**CHABOT-LAS POSITAS  
COMMUNITY COLLEGE DISTRICT  
PURCHASING DEPARTMENT**

**Addendum No. 4  
INVITATION TO BID No.: B20/21-08  
Agriculture Science, Horticulture Facility Project**

CLPCCD - LAS POSITAS COLLEGE  
**AGRICULTURE SCIENCE HORTICULTURE FACILITY**  
3000 CAMPUS HILL DRIVE,  
LIVERMORE, CA 94551

**AA141**

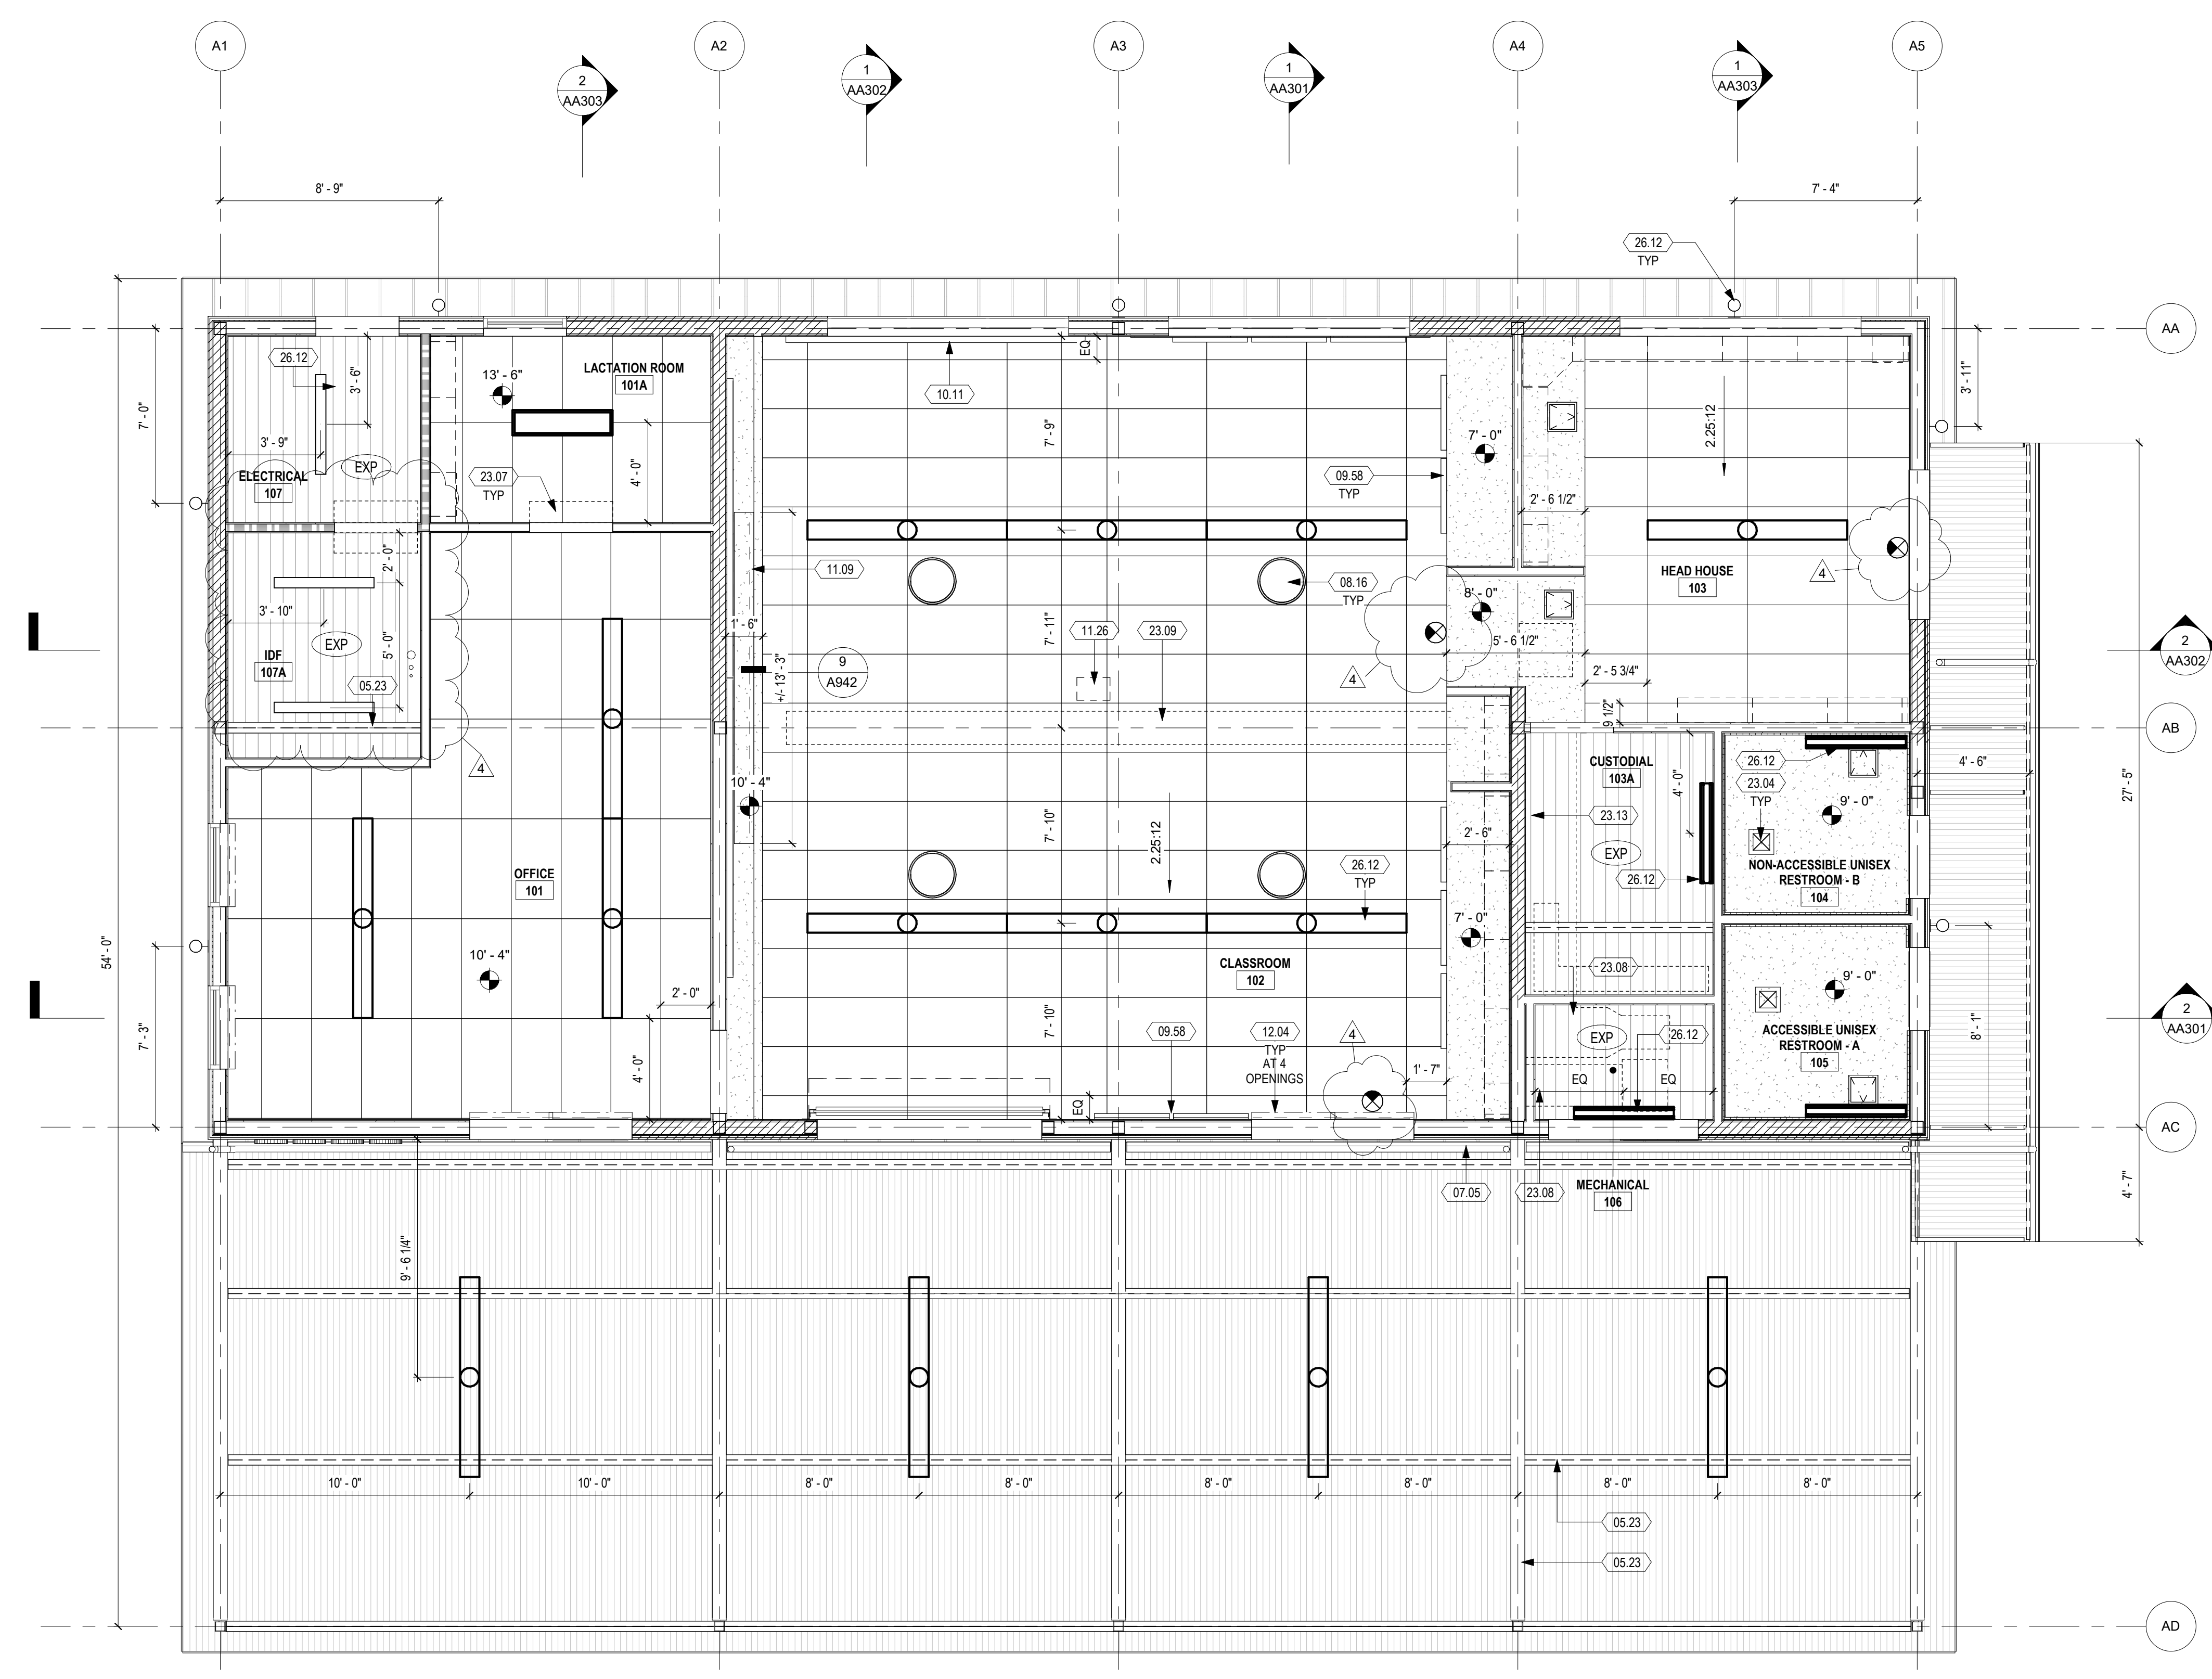
- e. Updated location of Max. Occupancy signage to match elevation.
  6. **Sheet AA141 – Classroom Building Reflected Ceiling Plan:**
    - a. Depicted exit lights.

- b. Depicted conduit in IDF Room 107A in revised location.
    - c. Dimensioned light fixtures in IDF Room 107A.
  7. **Sheet AA501 – Interior Elevations:**

**2 CLASSROOM - EAST**  
1/4" = 1'-0"

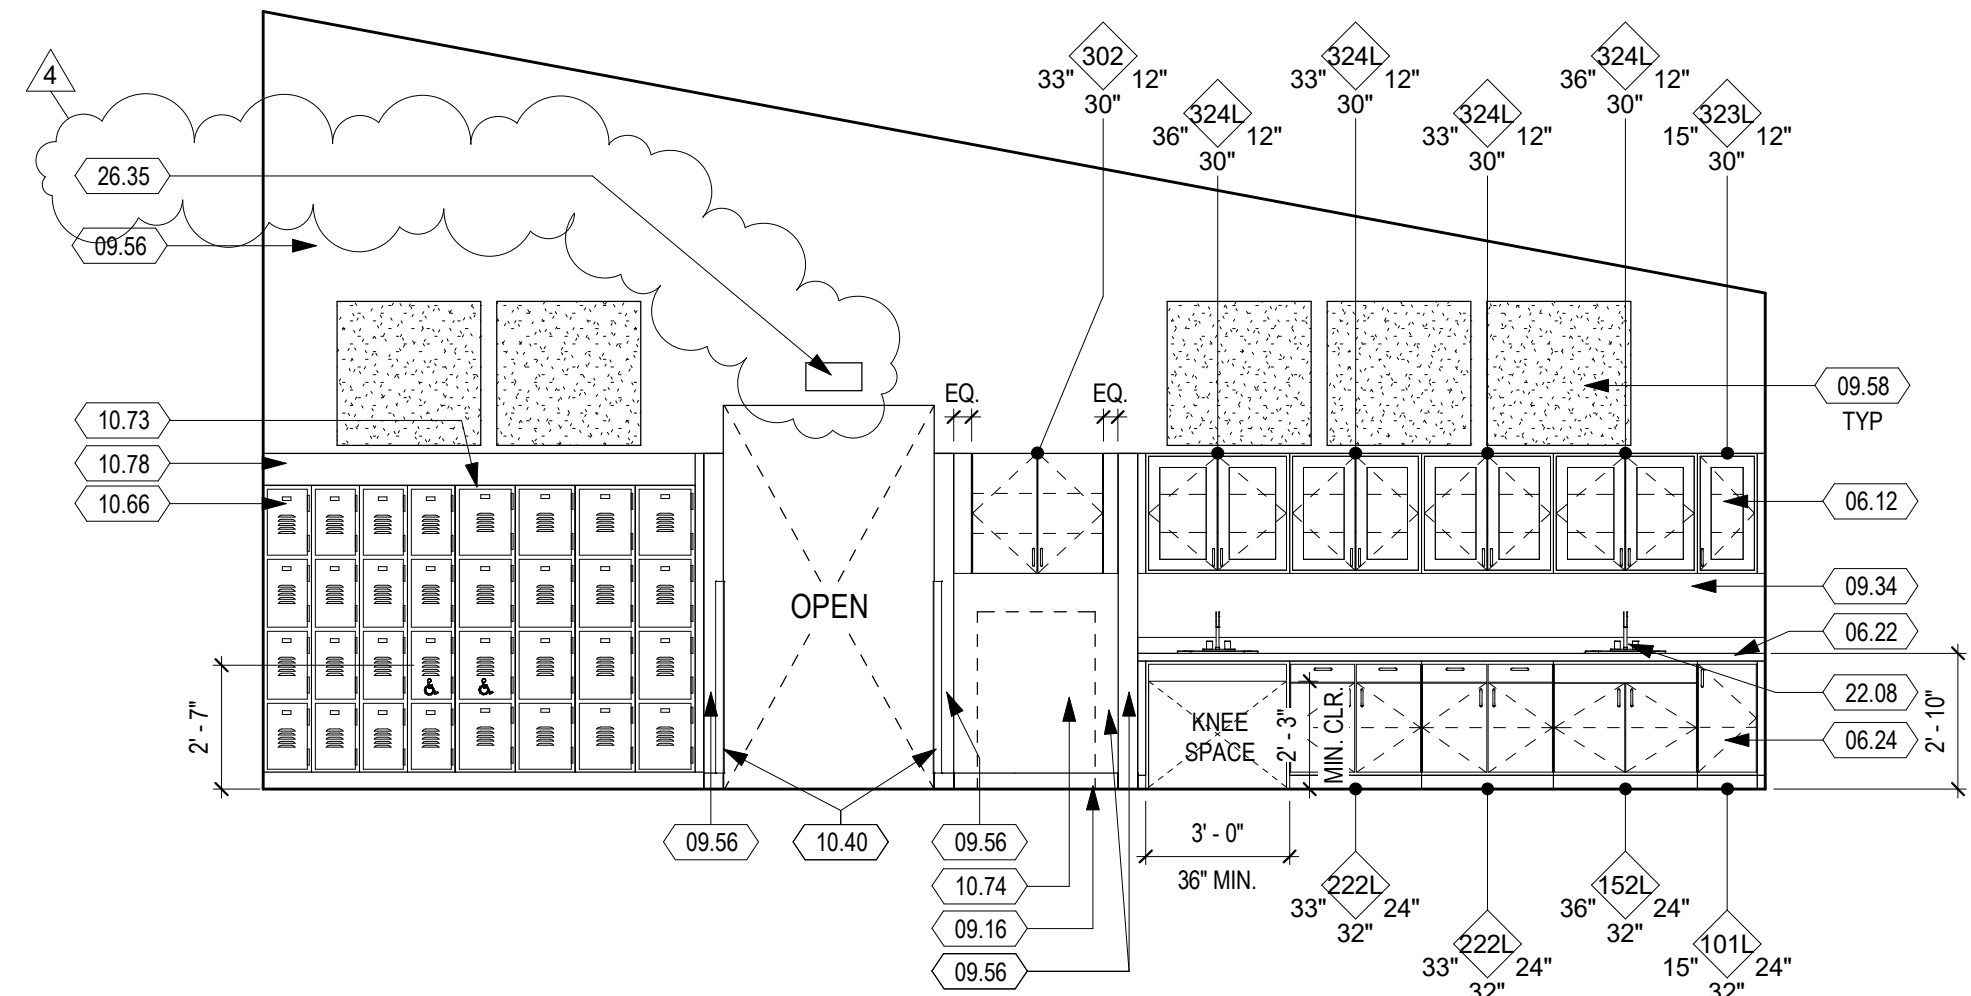
- a. Added detail references at Keynotes 10.54, 10.87 and 10.88.
    - b. Depict wall mounted exit light location on Detail 2 Classroom – East elevation.

**3 CLASSROOM - SOUTH**  
1/4" = 1'-0"

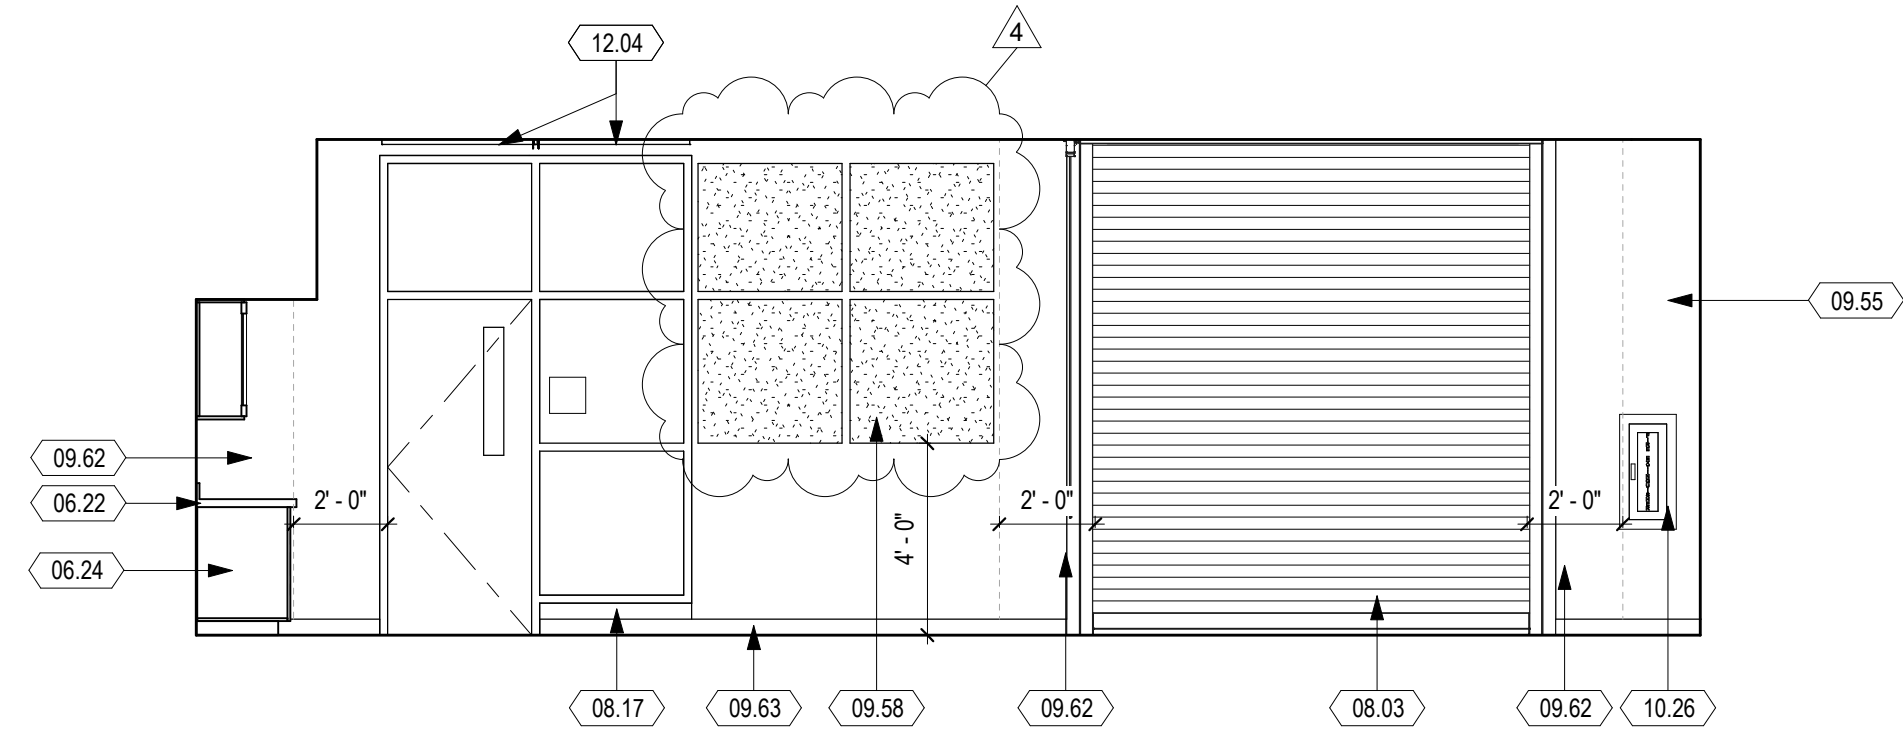
- c. Revised configuration of acoustical wall panel on Detail No. 3 Classroom South elevation.
    - d. Depict batt insulation along the ceiling and wall-mounted light fixture on Detail 7 Custodial – North elevation.

**3 HEAD HOUSE - EAST**  
1/4" = 1'-0"

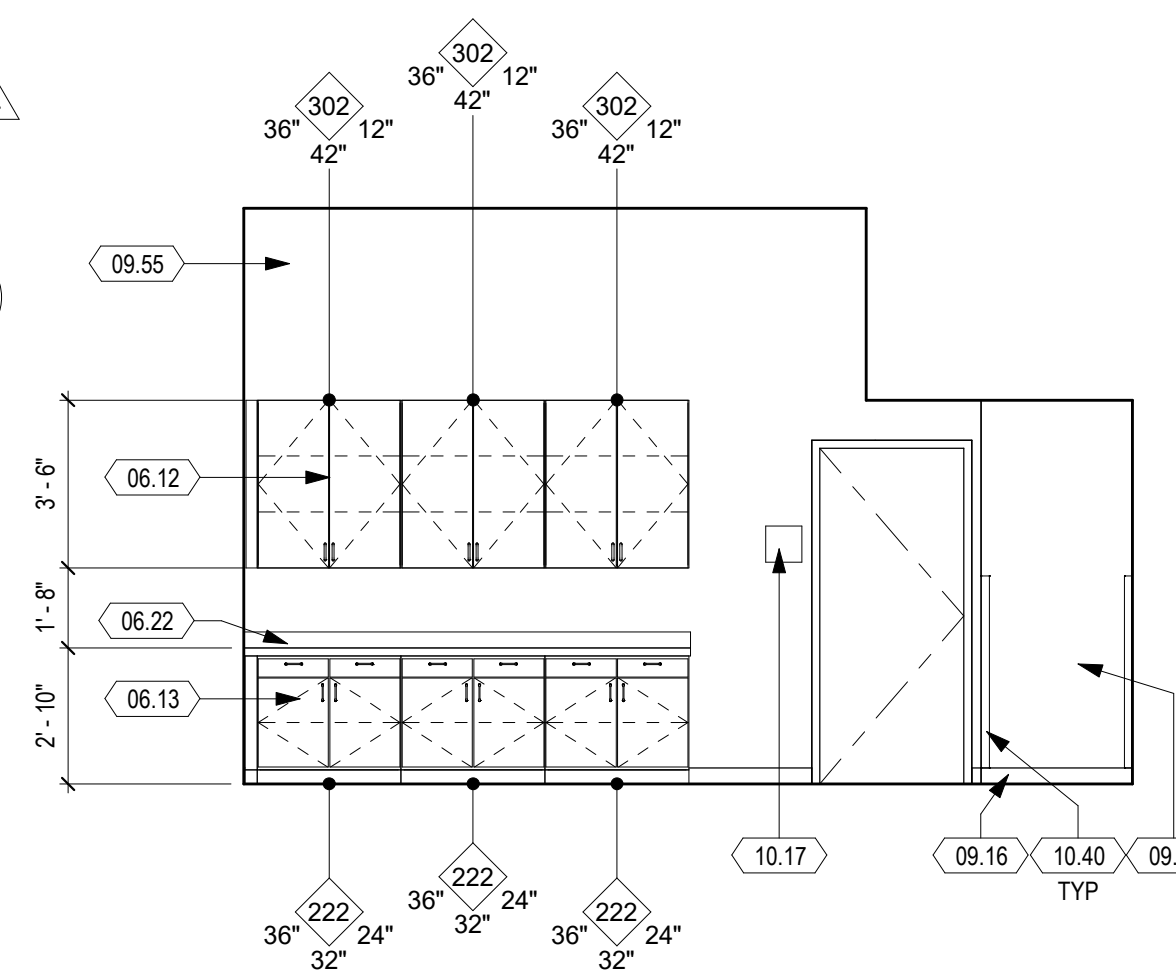
8. **Sheet AA502 – Interior Elevations:**
    - a. Delete Keynote 08.18 and its reference on Detail No. 12 Lactation Room - North elevation.
    - b. Depict wall mounted exit light location on Detail No. 3 Head House – East elevation.
